**To:** Patricia Davis, P.E., Brad Marshall  
**From:** Jonathan Tran, P.E. / Charles Cameron  
**Copy:** Matt Gaughan, P.E.  
**Date:** June 11, 2020  
**Subject:** CWWTP1 Change Order 0001

For the Central Wastewater Treatment Plant Expansion project, the Owner's Representative Team recommends approval of the attached Change Order 0001 in the amount of \$288,607.76 and 34 additional days to the contract with BAR Constructors, Inc. for the nine items in Table 1 below.

<b>Project:</b> <u>Central Wastewater Treatment Plant</u>	<b>Project Number:</b> _____
<b>Owner:</b> <u>City of Pflugerville</u>	<u>88</u>
<b>Contractor:</b> <u>BAR Constructors</u>	<u>279</u>
<b>Engineer:</b> <u>Freese and Nichols</u>	<u>PFL16607</u>
<b>PCM:</b> <u>Plus Six Engineering</u>	<u>19-211</u>

**Change Order No.:** 001      **Date:** 06/11/2020

CITY OF PFLUGERVILLE  
 CENTRAL WWTW EXPANSION  
 PHASE I IMPROVEMENTS  
 MECHANICAL  
 EFFLUENT FILTERS TOP PLAN

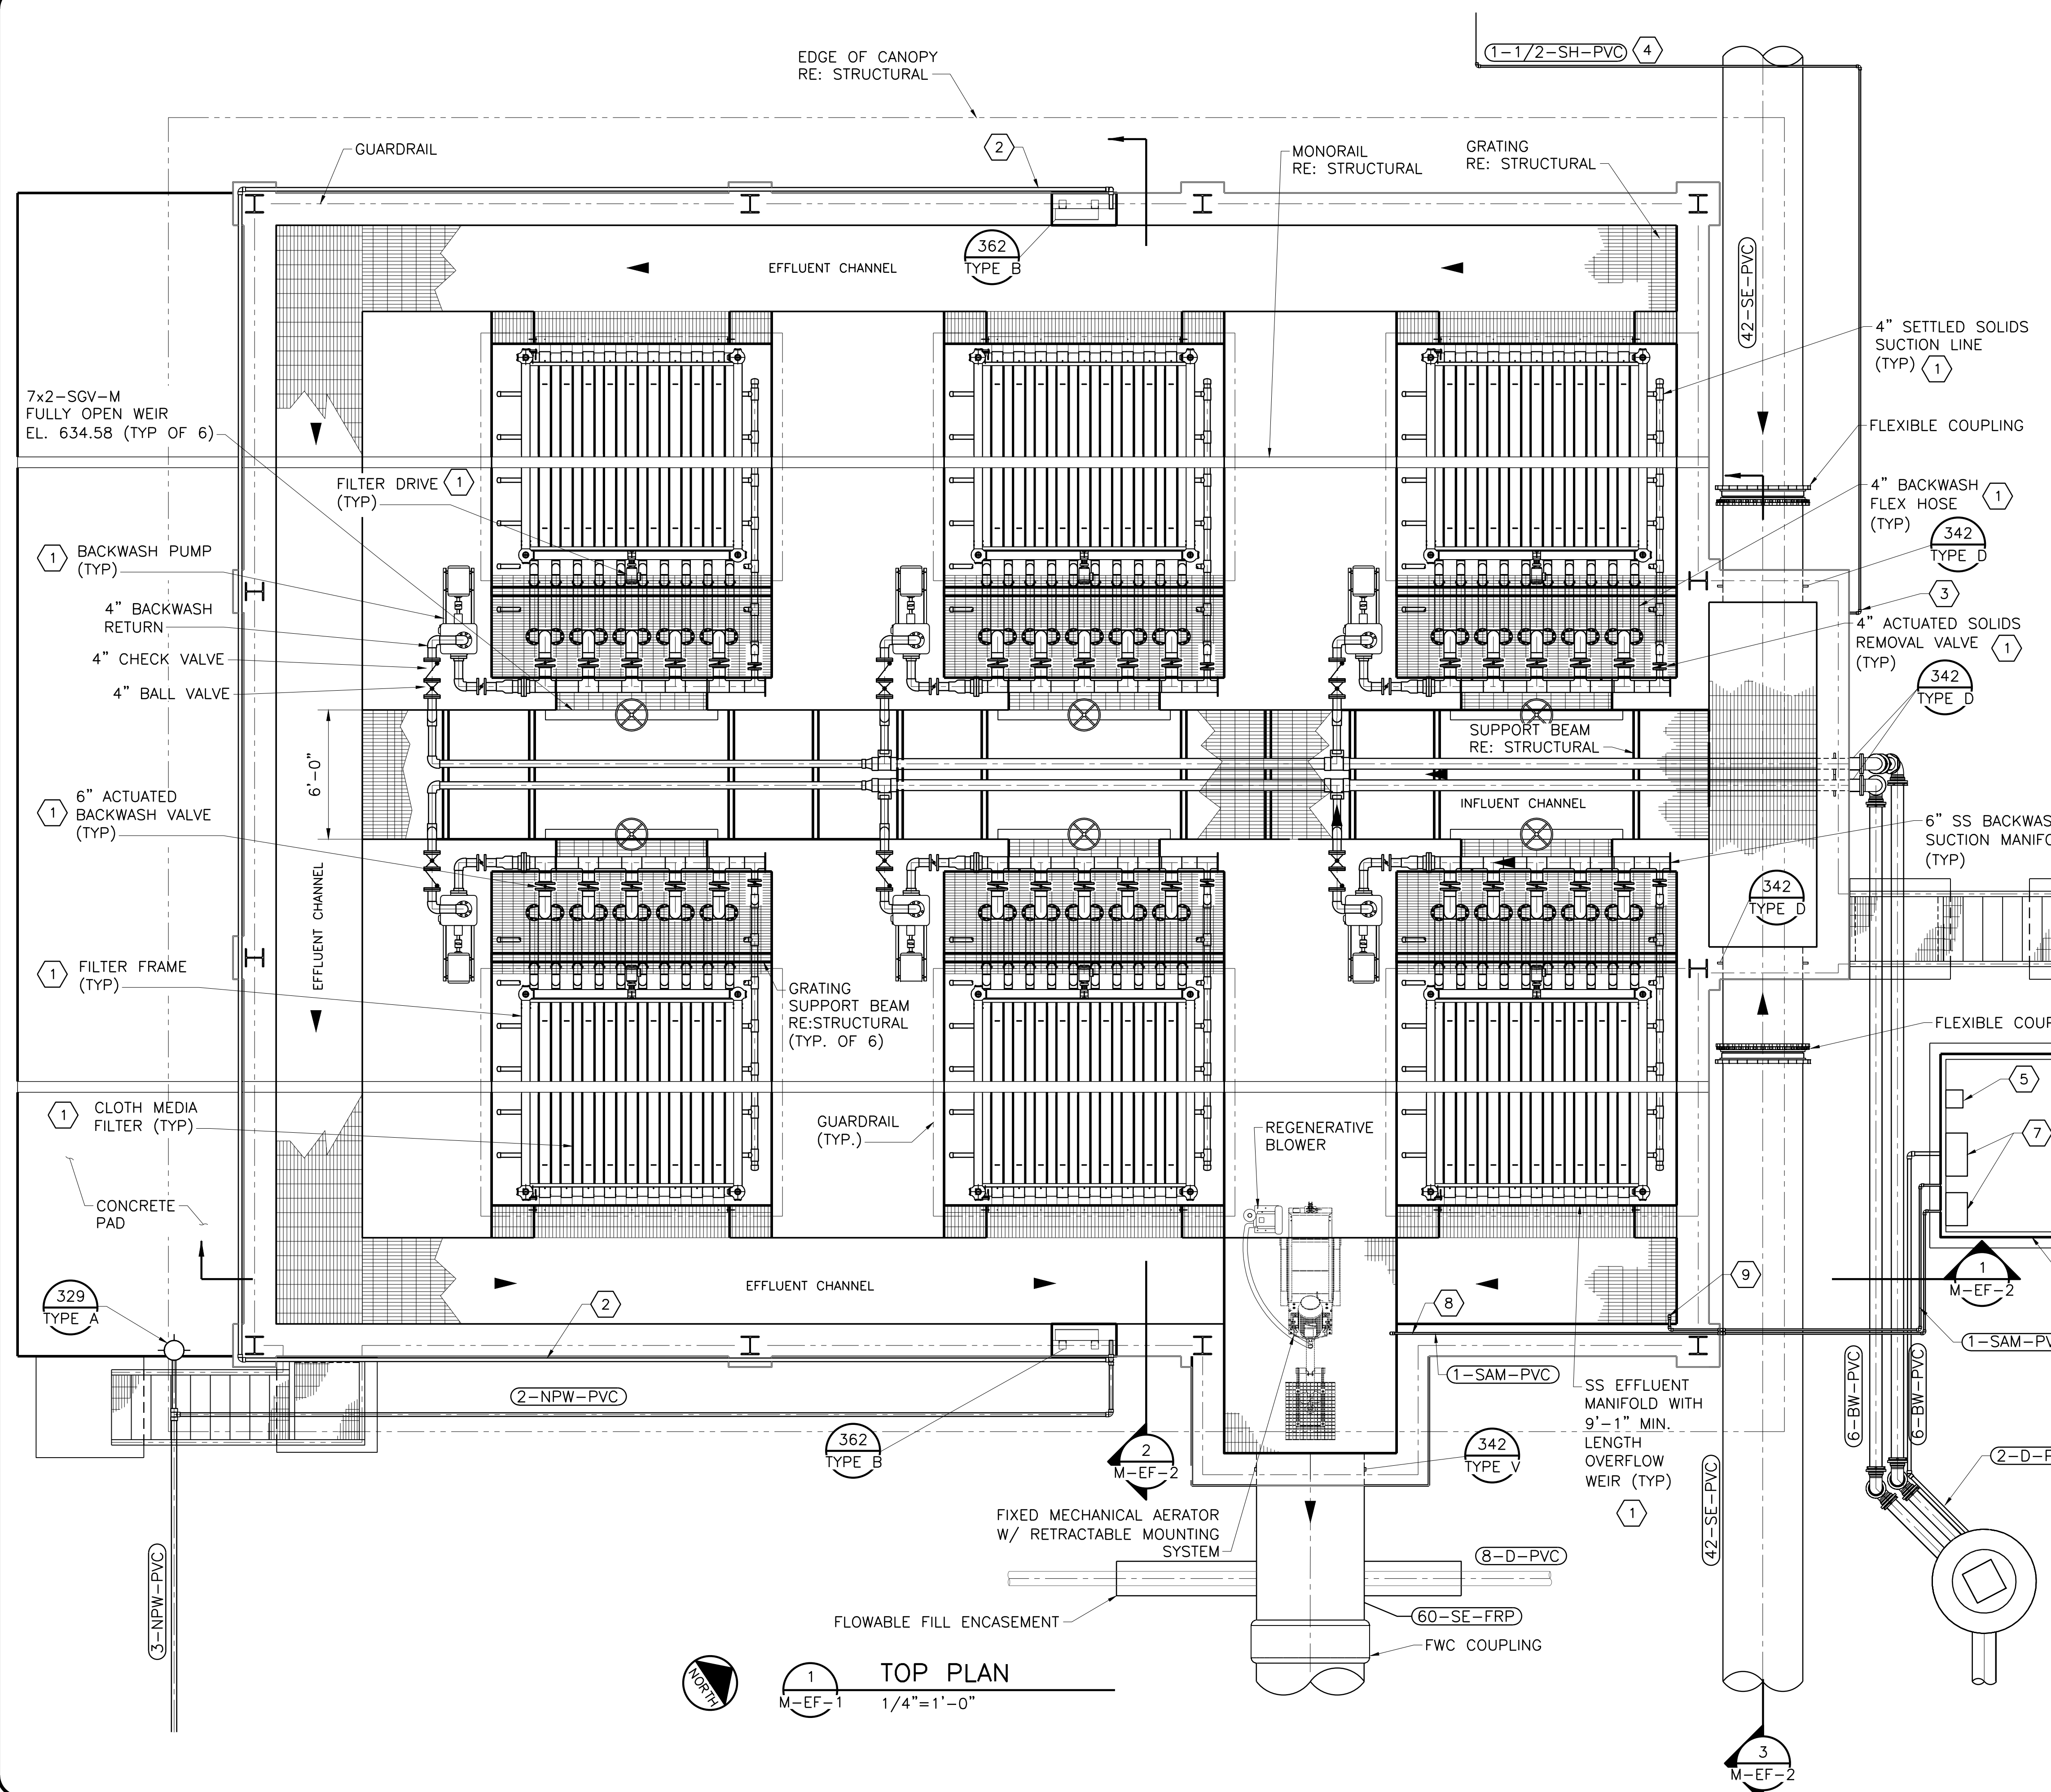
- Provide new 6' x 6' x 7.5' fiberglass building for housing P-analyzer and turbidimeters at effluent filters. Fiberglass building shall be one-piece standard accessories building by Tracom or approved equal.

- 4 1/2" TUBING IN 1-1/2" SCH 40 PVC CONDUIT
- 5 NEW HACH TU5300 SC TURBIDIMETER, SEE SHEET M-AS-12.
- 6 ~~RELOCATED~~ PHOSPHORUS ANALYZER BUILDING FROM EXISTING MIXED LIQUOR JUNCTION BOX.

- 7 NEW PHOSPHORUS ANALYZER AND SAMPLE PUMP, SEE SHEET M-AS-12
- 8 1" PVC SAMPLE LINE TO BE FIELD ROUTED BY CONTRACTOR TO LOCATION SHOWN. EXTEND SAMPLE LINE INTO BASIN, 6" ABOVE BASIN FLOOR. SUPPORT PIPE ALONG BASIN WALL WITH 316 SS PIPE STRAPS EVERY 5'-0" AT MINIMUM. PROVIDE OPENING IN METAL GRATING FOR PIPING.

- 9 1" PVC SAMPLE RETURN LINE TO BE FIELD ROUTED BY CONTRACTOR TO LOCATION SHOWN. EXTEND SAMPLE RETURN LINE INTO BASIN, 3" BELOW TOP OF WALL. SUPPORT PIPE ALONG BASIN WALL WITH 316 SS PIPE STRAPS EVERY 5'-0" AT MINIMUM. PROVIDE OPENING IN METAL GRATING FOR PIPING.

PROVIDE NEW 6'X6' FRP BUILDING

CITY OF PFLUGERVILLE  
 CENTRAL WWTB EXPANSION  
 PHASE I IMPROVEMENTS  
 CIVIL  
 YARD PIPING PLAN VII

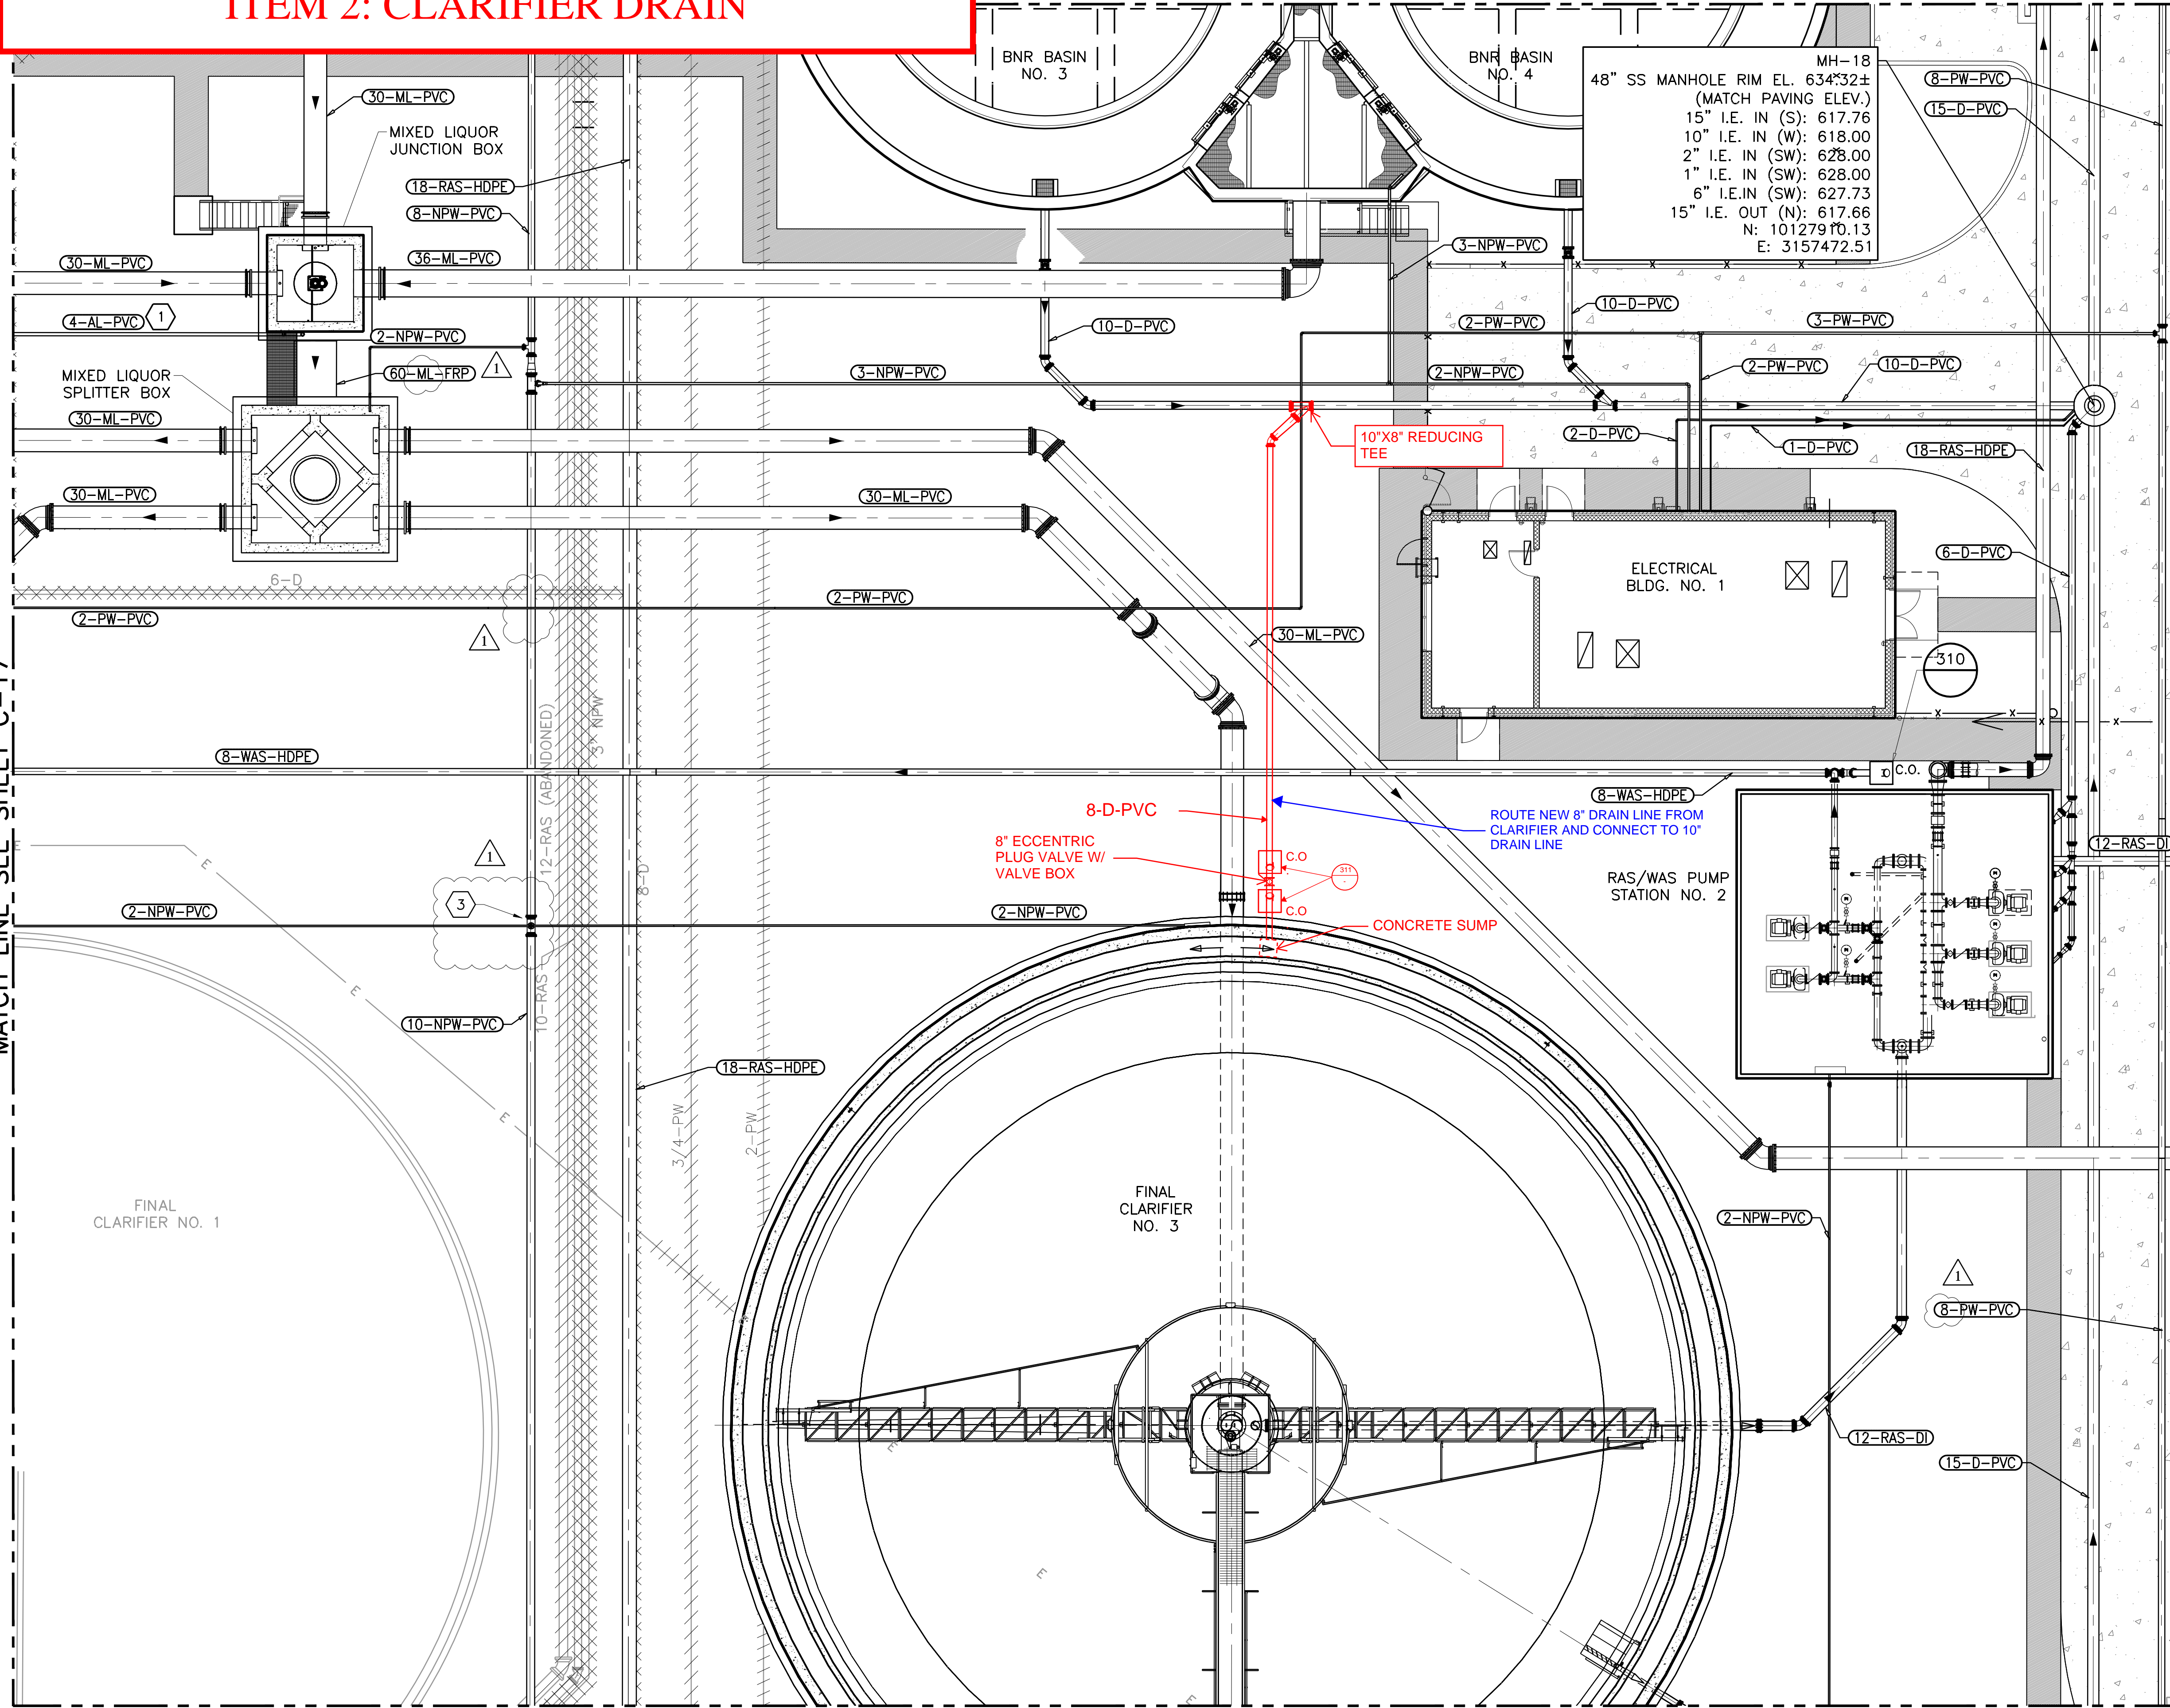
A drain line will be installed extending from Clarifier #3 to the 10" drain line located north of Clarifier #3 replacing the 12" drain with plug currently shown on the drawings. Reference the attached markups.

- New sump in clarifier for connection to 8" PVC drain line.
- Removal of proposed 12" tee and drain plug
- New below grade 8" PVC drain line extending 63' from Clarifier #3 drainage sump to the 10" PVC drain line located north of Clarifier #3.
- New below grade 8" plug valve installed on 8" drain line just outside of the clarifier wall.
- Two new cleanouts installed on either side of the 8" plug valve.
- New 8" PVC 45 degree bend to be installed prior to connection with 10" drain line.

• New tie-in to 10" drain line.

CITY OF PFLUGERVILLE  
**CENTRAL WWTB EXPANSION  
 PHASE I IMPROVEMENTS**  
 STRUCTURAL  
**UV DISINFECTION BASIN & SYSTEM  
 FOUNDATION PLAN**

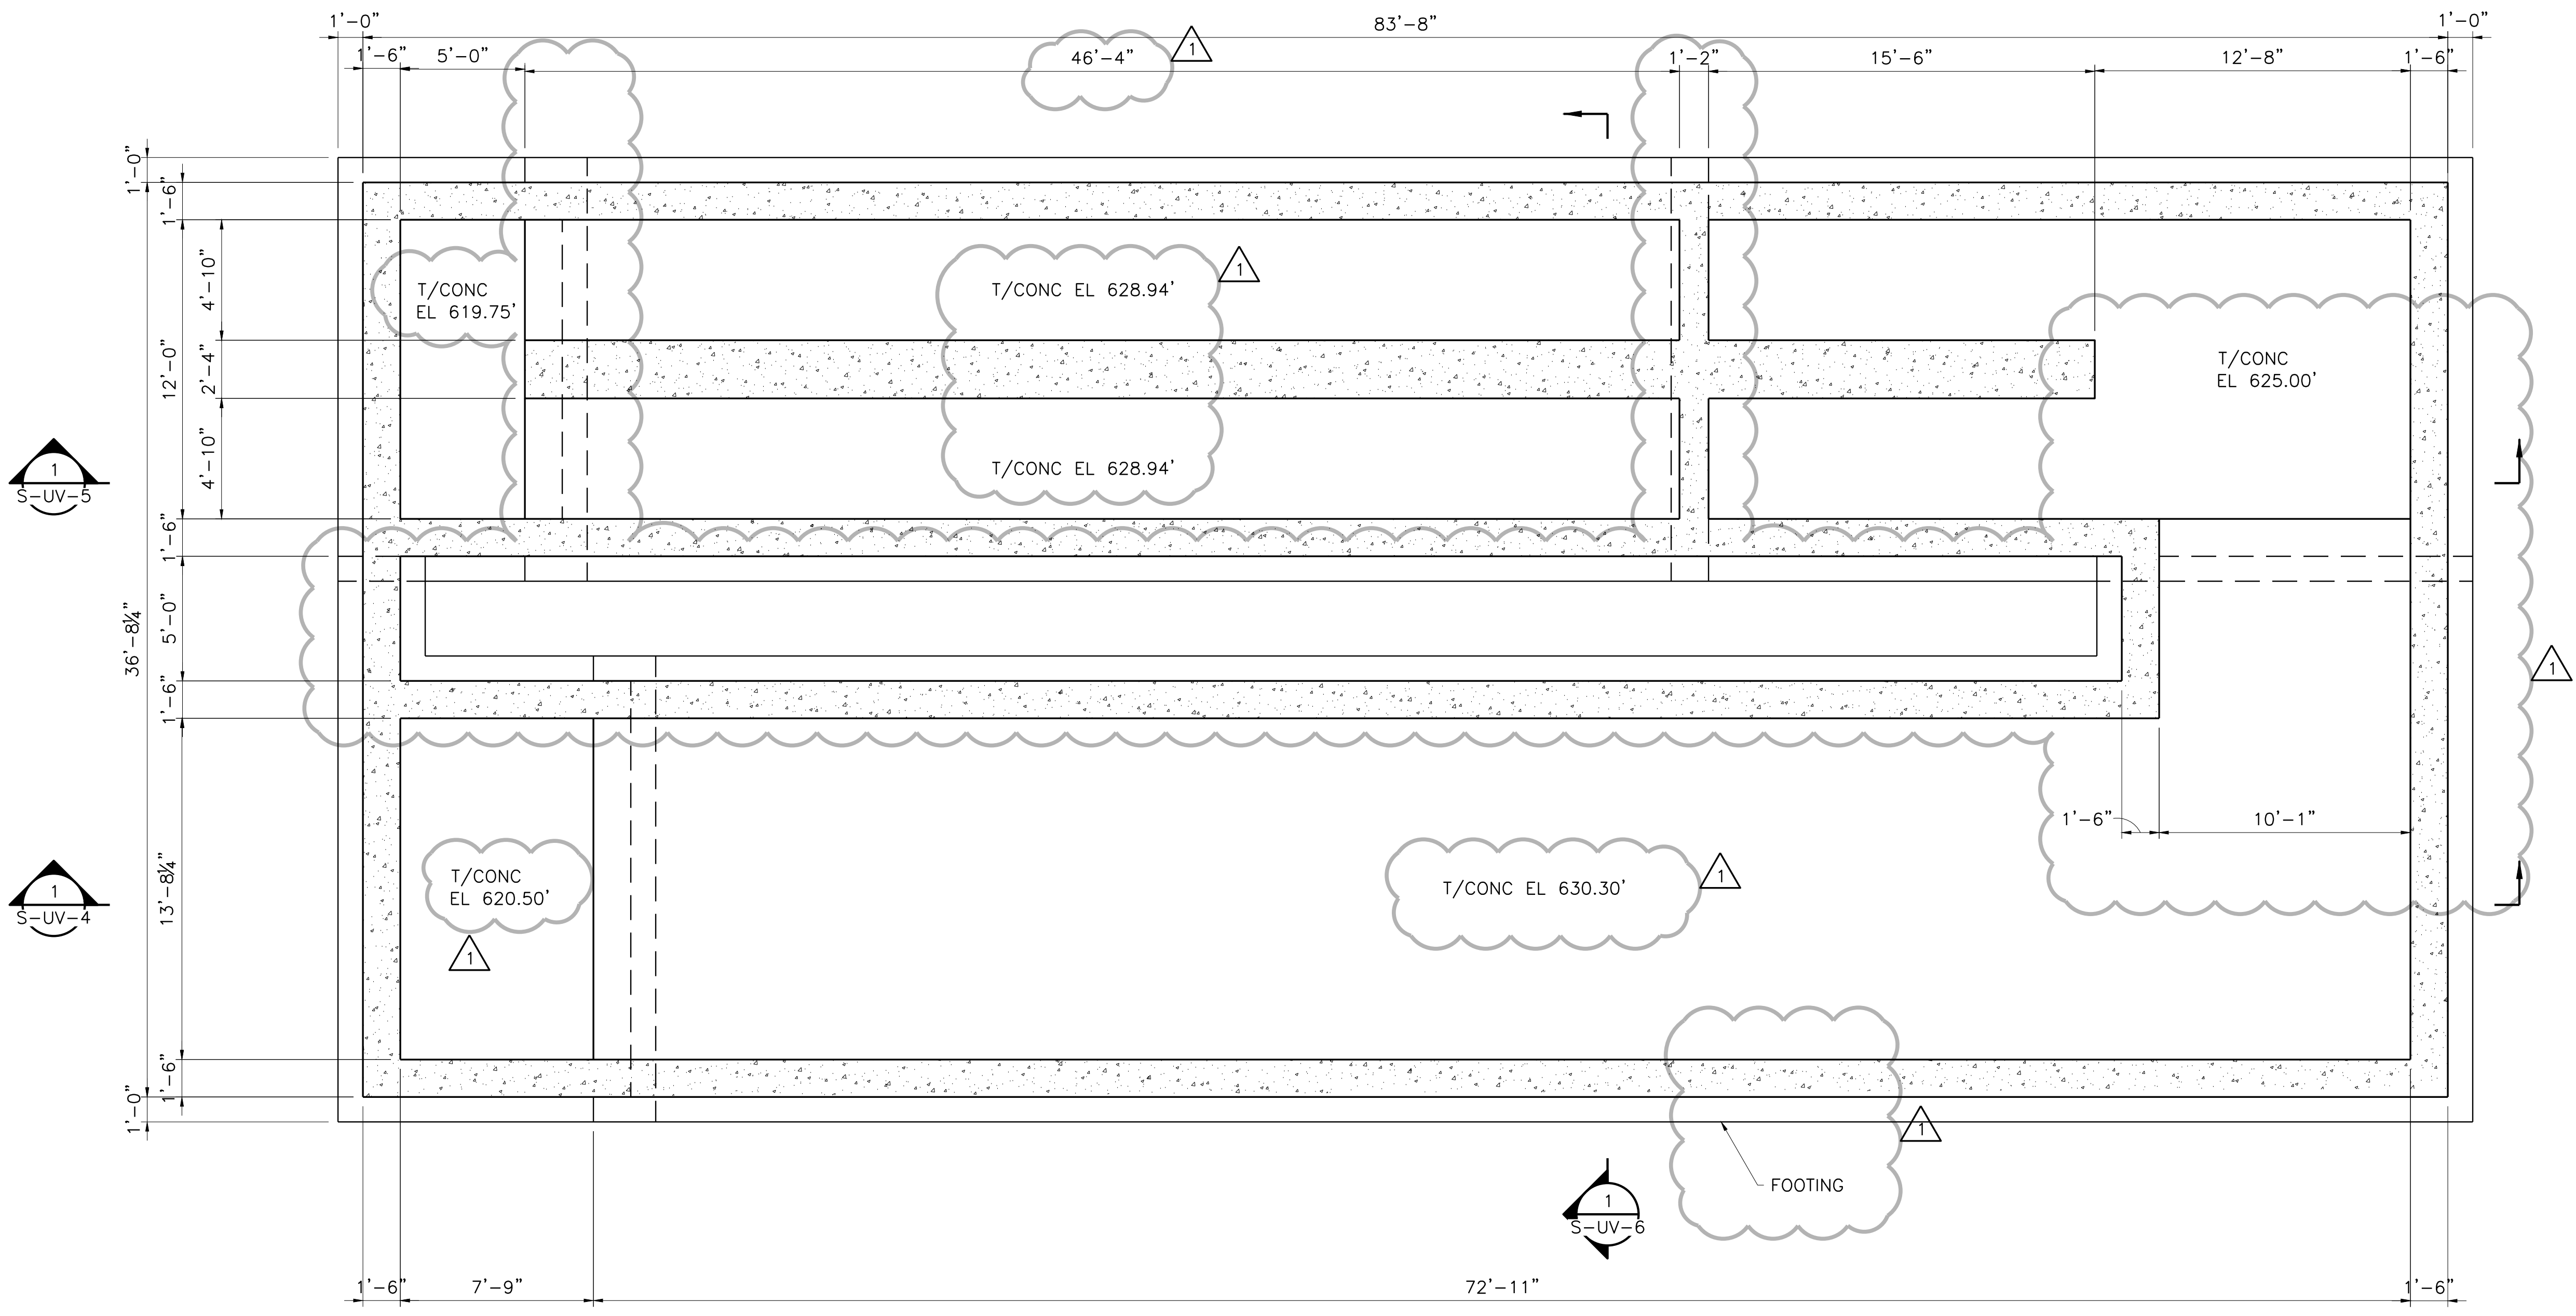
Modifications to sheets S-UV-1 to S-UV-8 to clarify sections and details of the design.
